**DANE COUNTY DEPT. OF
PUBLIC WORKS, HIGHWAY &
TRANSPORTATION**

ADDENDUM

RFB NO. 321001 - ADDENDUM NO. 02

DANE COUNTY JCO / NIP SECURITY UPGRADES

1. **Sheet A401** (Rev. 2, Addendum 02, May 20, 2021)

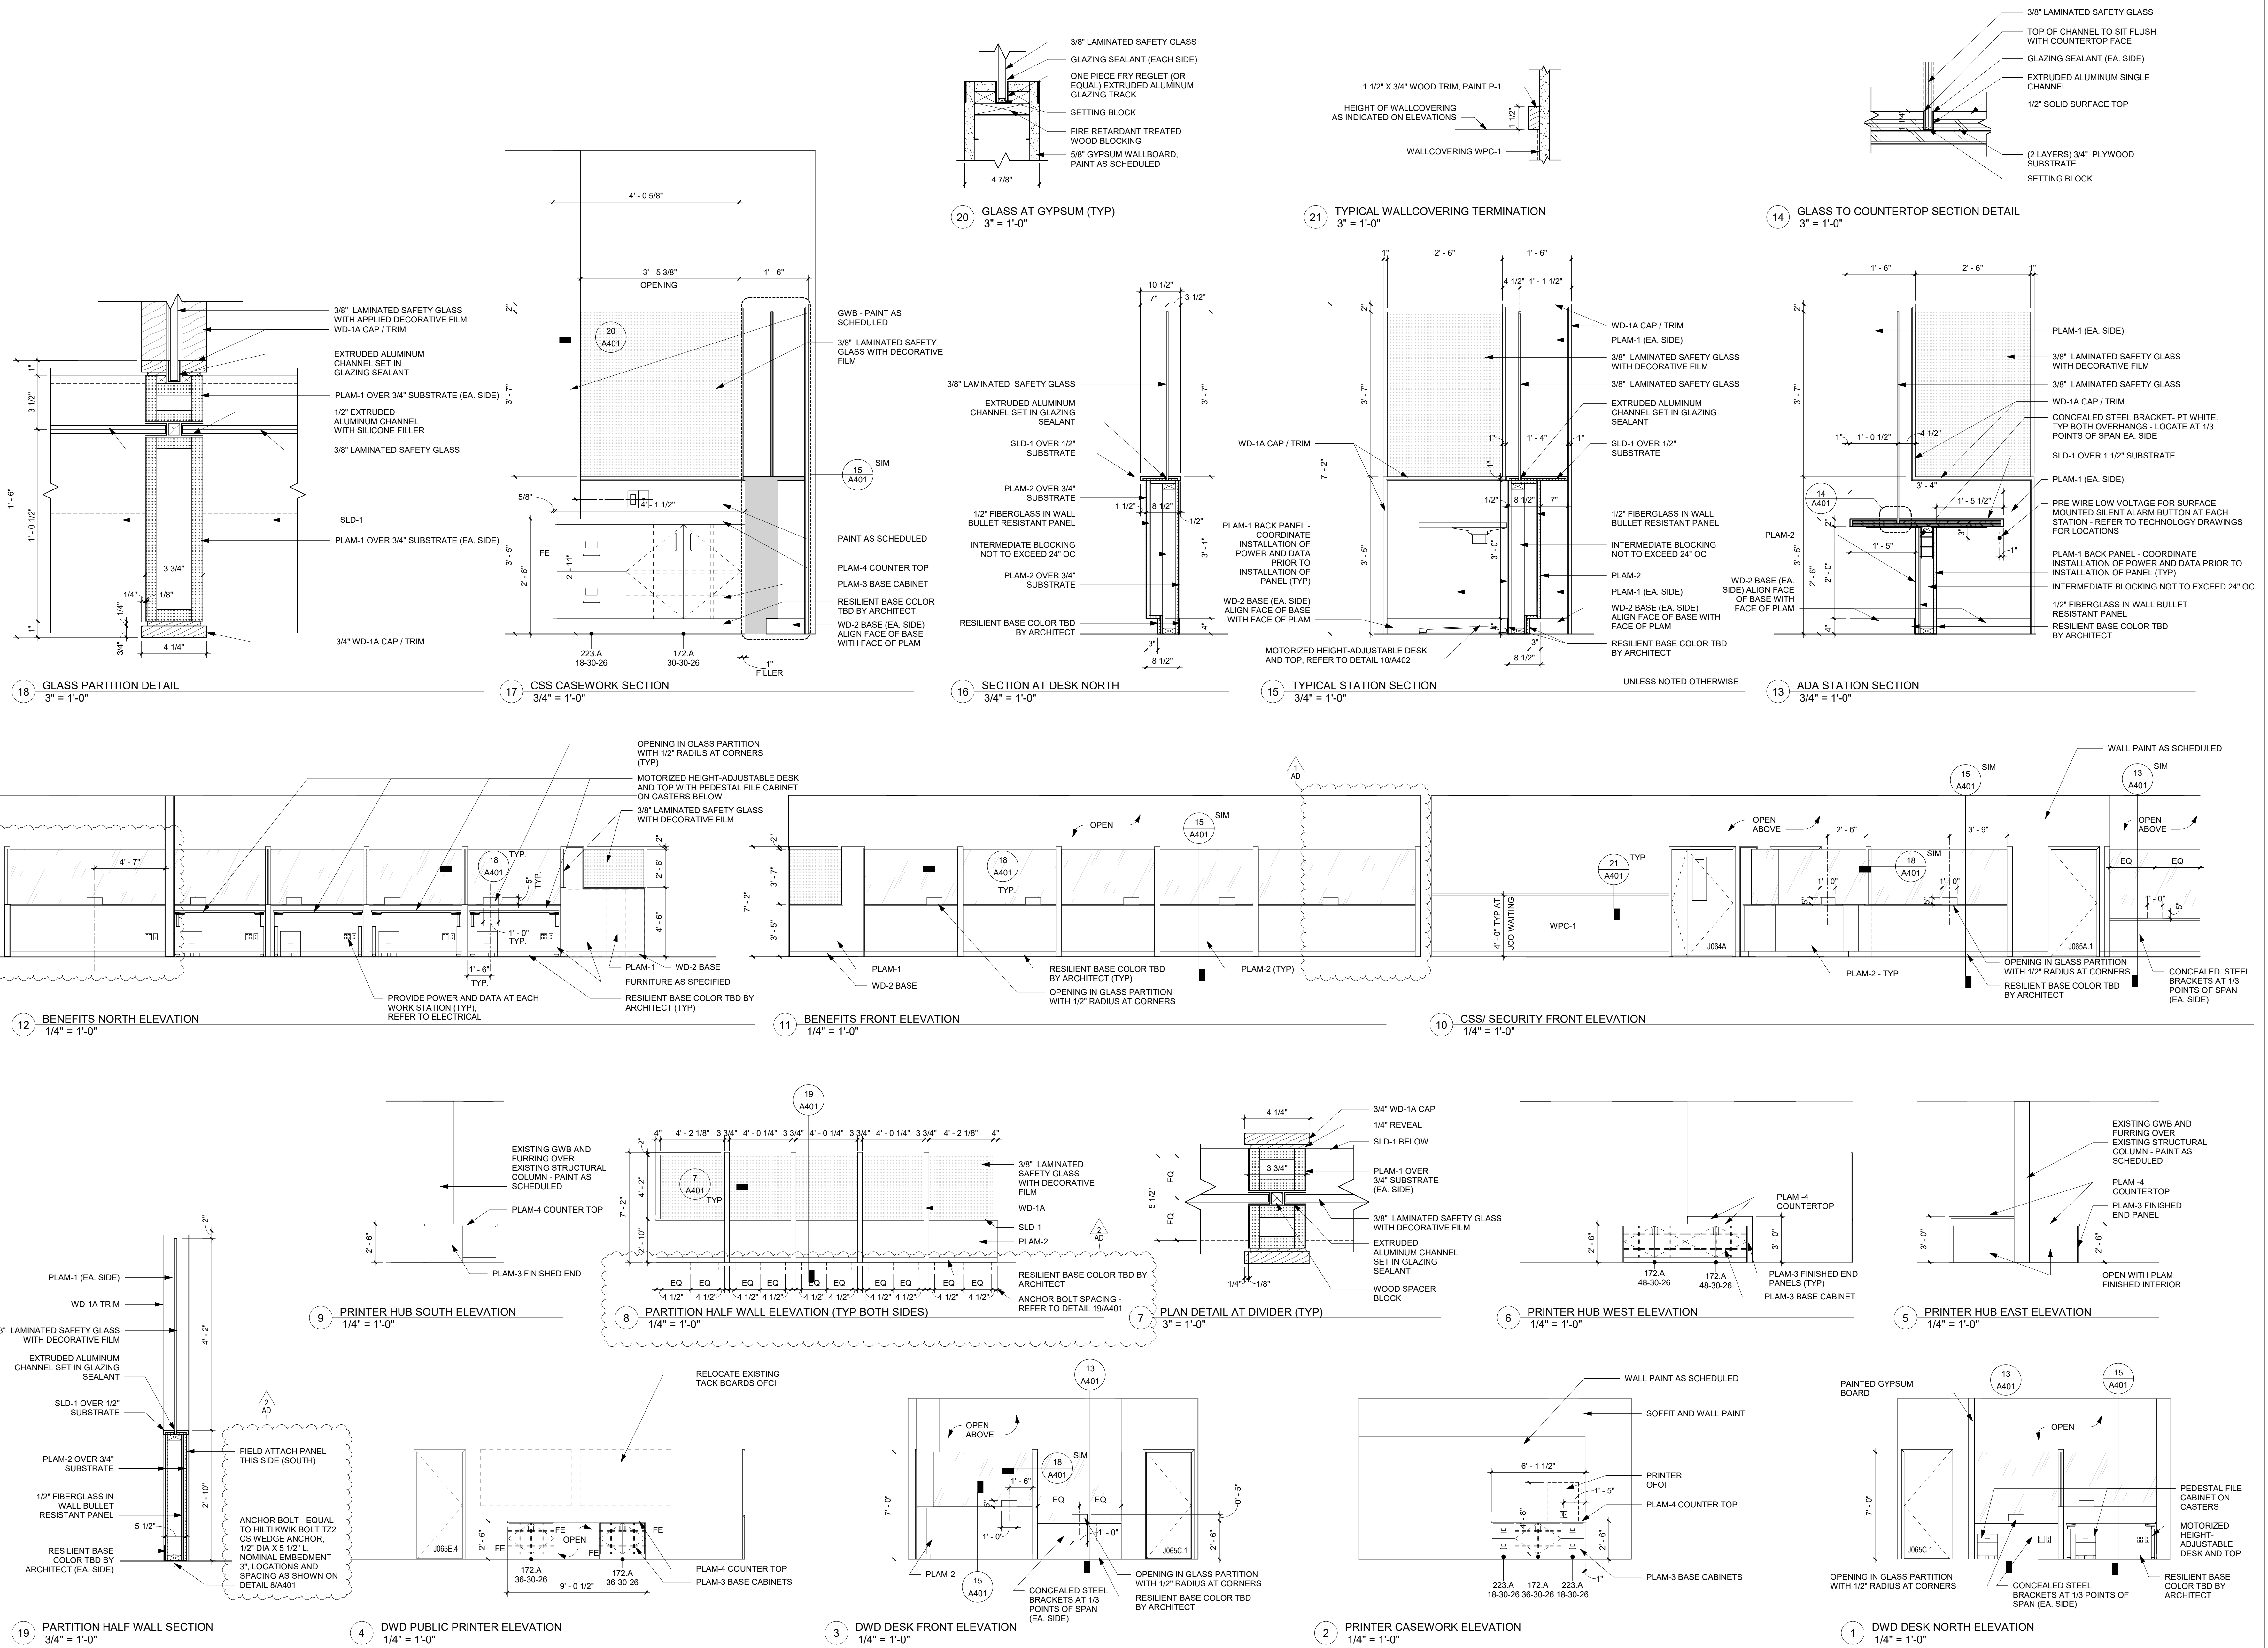
Q6: How are we going to fasten the Partition half wall at the entrance (8/A401 and 19/A401)?

Revised drawing sheet A401 replaces previously issued sheet, revised to show wedge anchor detail to floor for additional stability.

A6: OPN has revised 8/A401 and 19/A401 to show wedge anchors to be embedded into concrete floor to help prevent overturn. The revised detail is issued as part of Addendum 2.

Existing CCTV Equipment Photos:

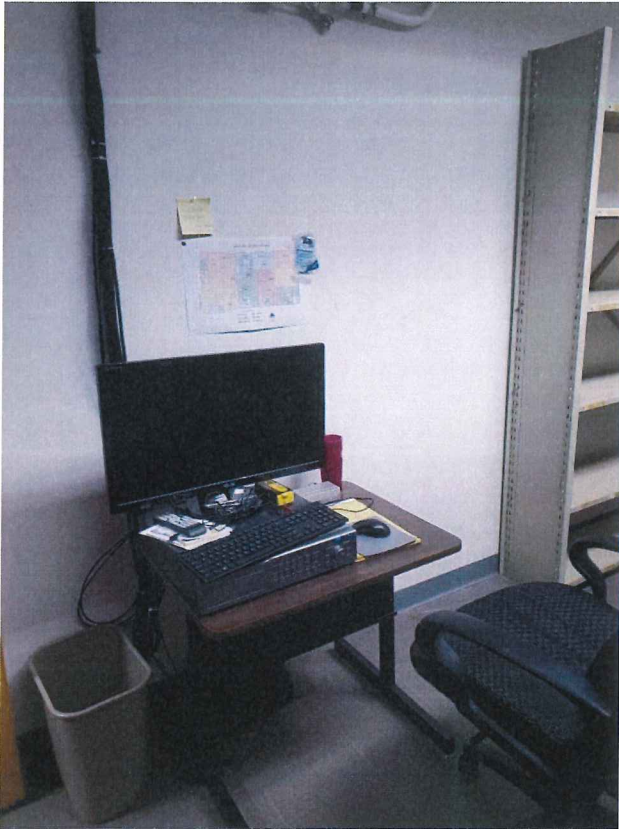
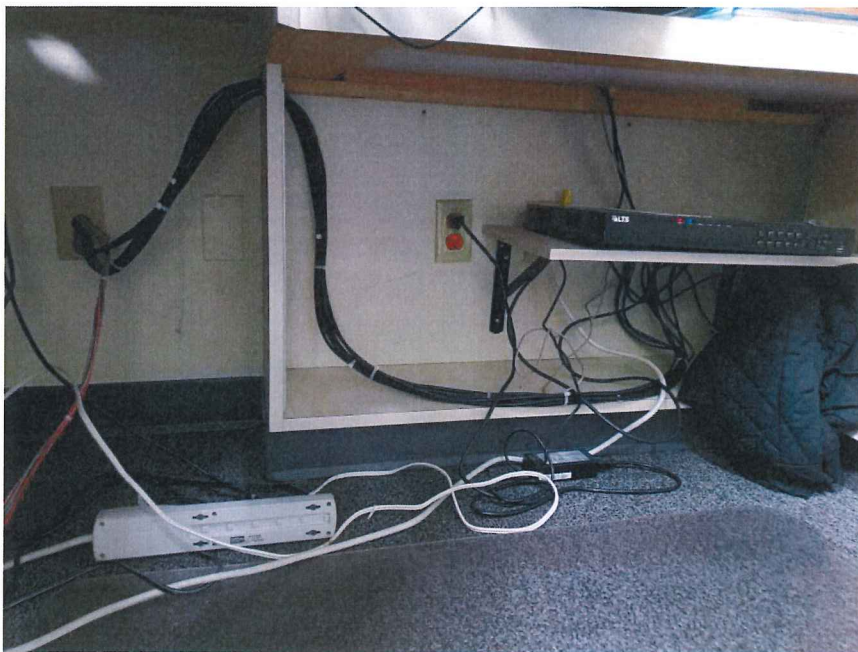
Q6: Is a serial number or a model number on the access control panel and CCTV (Even a picture could service of these panels or head end units.)?

A6: Photos are attached of existing equipment – per construction documents, equipment is specified to be replaced.
